Wollongong Local Planning Panel Assessment Report | 1 Aug 2018

WLPP No.	Item No. 3
DA No.	DA-2017/1316
Proposal	Residential - demolition of existing dwelling houses and construction of five (5) townhouses
Property	178-180 Lawrence Hargrave Drive, THIRROUL NSW 2515 Lot 2 DP 329046 and Lot A DP 392508
Applicant	Develop My Land
Responsible Team	Development Assessment & Certification – City Wide Planning Team (JS + VL)

ASSESSMENT REPORT AND RECOMMENDATION

Figure 5: Extent of three storey development demonstrated by applicant

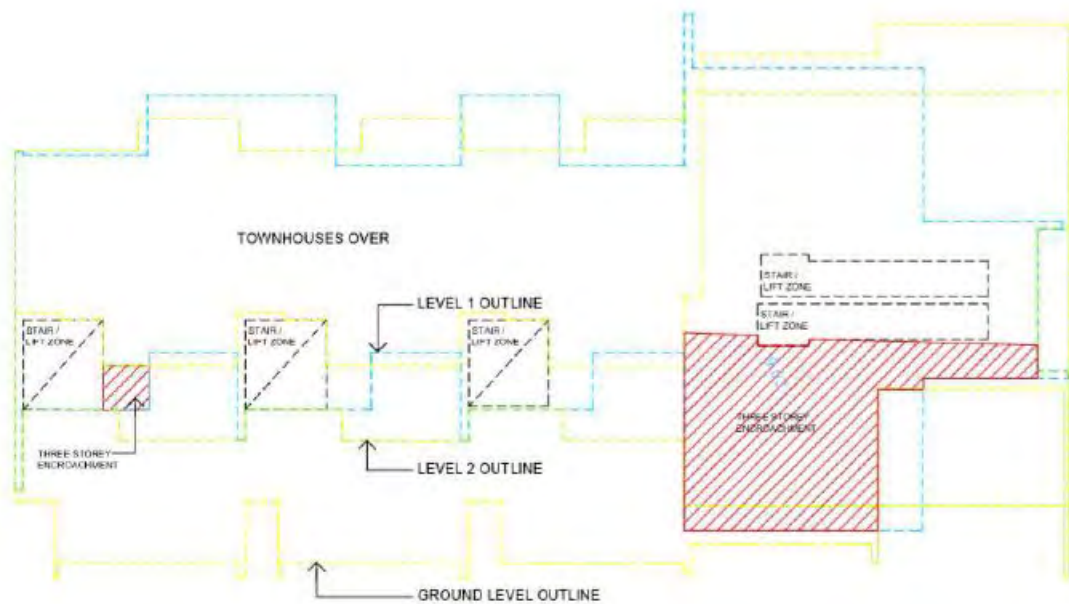
Control	Comment
1. The variation statement must address the following points:	
a) The control being varied; and	The variation request statement incorrectly identifies the control being varied as 4.1, which also relates to Number of Storeys, but for dwelling houses and dual occupancies only. The control assumed to be varied is 5.1.

b) The extent of the proposed variation and the unique circumstances as to why the variation is requested; and	<p>The applicant has provided a plan, provided at Figure 5 below which demonstrates the extent of the variation.</p> <p>The variation is requested on the basis that the site cross fall enables the location of the garages and driveway as presented and leads to the cutting in of the basement arrangement. The applicant has stated that the development would not result in an exceedance of the WLEP 2009 9m height limit, and would not result in unreasonable overshadowing of the adjoining properties.</p> <p>The statement also indicates that the variation relates to only a small portion of Units 3-5, with the extent of three storey development for Units 1 and 2 being larger.</p> <p>The statement indicates that the variation should be permitted as the building does not appear on any elevation to be three storeys in height, and the design</p>

has sympathetically utilised varying elevational forms and planter boxes and varying setbacks to mitigate any negative impacts relating to the bulk and scale.

c) Demonstrate how the objectives are met with the proposed variations; and	<p>The objectives of the control are as follows:</p> <ul style="list-style-type: none"> a) <i>To encourage buildings which integrate within the existing streetscape and the desired future character for the area.</i> b) <i>To minimise the potential impacts of overshadowing and overlooking on adjacent dwellings and open space areas.</i> <p>The applicant has indicated that they consider the development consistent with the above objectives.</p> <p><u>Council comment:</u></p> <p>The development is not considered to be consistent with the existing streetscape, and the desired character of the area. See comments at Chapter D1 regarding consistency of the development with the Character Statement for Thirroul.</p> <p>Despite the design of Units 3, 4 and 5 including minimal areas of technical three storey development, a considerable amount of the floor area of Unit 2 is three storeys. It is considered that a design for the site could be presented which did not result in areas of three storeys.</p> <p>The design presented is also not considered to have minimised the potential for overshadowing and overlooking. The elevations and sections (Figure 6) provided clearly demonstrate that the proposal presents from the southwest as a three storey development. The design also proposes south west facing balconies for Units 2-5. Units 3, 4 and 5 are proposed with the primary POS areas on the northern side of the development, but are also proposed with balcony areas orientated to the south west. Concern was raised as to the privacy implications from this area, however rather than be removed or reduced in size, additional screening has been added to the elevation which presents additional scale to the elevation.</p> <p>The applicant disputes this position, as outlined in the urban context analysis provided at Attachment 4. The three storey development examples are primarily older developments which would have been constructed prior to the number of storeys development controls being imposed. This control has been enforced in the immediate area, notably the property immediately adjoining development to the north. Furthermore, the presentation that the site could be developed more intensively and with greater impacts as a result of the</p>

Medium Density Housing Code adoption is not considered to be directly relevant, as the adoption of this code has been deferred by a further 12 months in the Wollongong LGA for further consideration.
d) Demonstrate that the development will not have additional adverse impacts as a result of the variation.	<u>Council comment:</u> There development is considered likely to result in adverse impacts as a result of the variation if granted.
<p>Comment:</p> <p>The requested variation has been considered and is not supported. The applicant has been advised of this position on two occasions.</p>

Figure 7: Deep soil zone variation extent

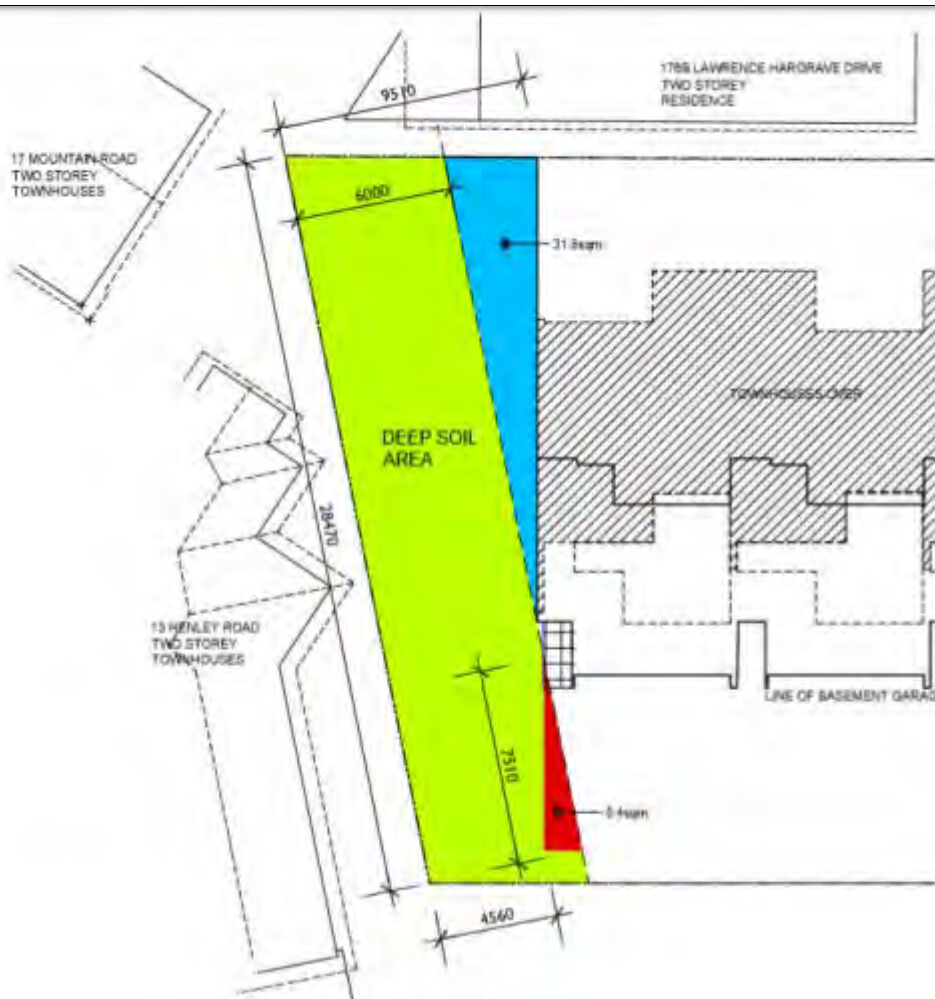
Control	Comment
2. The variation statement must address the following points:	
a) The control being varied; and	The variation request statement identifies the control to be varied as control 5.9.2.2.

b) The extent of the proposed variation and the unique circumstances as to why the variation is requested; and	<p>A plan, provided at Figure 7 below demonstrates the extent of the variation.</p> <p>The variation is requested on the basis that the deep soil zone exceeds the 6m width to the north of the site, maximising the landscape potential to integrate the development and create habitat for native and indigenous planting and bird life. A number of the palms to the rear of the existing development at 178 Lawrence Hargrave Drive are proposed to be transplanted in the deep soil zone.</p> <p>The statement also indicates that the variation relates to only a small portion of the extent of the deep soil zone, with the 5.4sqm of area not achieving the 6m width, being offset by more than 30sqm to the north and west of the development.</p> <p>The statement indicates that the proposed deep soil zone would meet the objectives of the WDCP 2009, and should be considered a singular uniform area extending along the full length of the rear of the site.</p>

c) Demonstrate how the objectives are met with the proposed variations; and	<p>The objectives of the control are as follows:</p> <ul style="list-style-type: none"> a) <i>To protect existing mature trees on a site and encourage the planting of additional significant vegetation.</i> b) <i>To encourage the linkage of adjacent deep soil zones on development sites, to provide habitat for native indigenous plants and birdlife.</i> c) <i>To allow for increased water infiltration.</i> d) <i>To contribute to biodiversity.</i> <p>The applicant has indicated that they consider the development consistent with the above objectives.</p> <p><u>Council comment:</u></p> <p>The development is not considered to be consistent with the deep soil zone requirements. The control provides the option for either 15% of the site area, or a continuous 6m wide area along the rear property boundary. The proposed development does not</p>

<p>achieve either. The subject site and surrounding areas are not considered or mapped to have any special biodiversity value and there is limited connection with similar zones on adjoining properties.</p> <p>The deep soil zone also contains a Sydney water sewer line and stormwater infrastructure, limiting planting in certain areas.</p>
<p>d) Demonstrate that the development will not have additional adverse impacts as a result of the variation.</p>	<p><u>Council comment:</u></p> <p>Considering the requested variation in conjunction with the other non-compliances as outlined throughout this report, the development is considered likely to result in adverse impacts should the variation be granted.</p>
<p><u>Comment:</u></p> <p>The requested variation has been considered and is not supported.</p>

Figure 19: south western elevation of dwelling at 176a Lawrence Hargrave Drive.

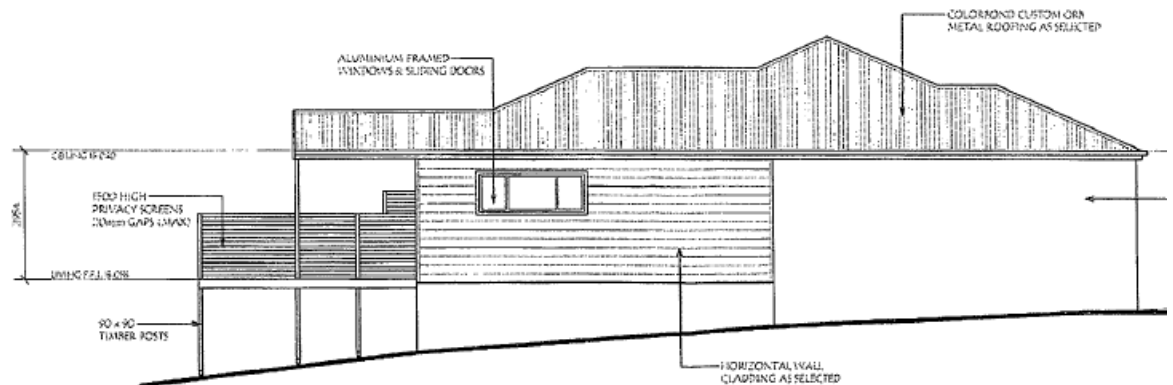
Views are currently available from the ground floor dining/living room window and POS area. The living/dining room window is the only window on this elevation. The sill height is 1.5m, and the POS area has privacy screening to a height of 1.5m also. The elevation of 176a is provided at Figure 19 below.

Given the high sill height and existing screening, the existing views are available from a standing position only.

Whilst the development is proposed to be setback more than 5m in this location, it is expected that the proposal would result in an impact on the views currently available and demonstrated by Figure 10 above. The remaining view would be of the very top of the escarpment only, over the proposed development.
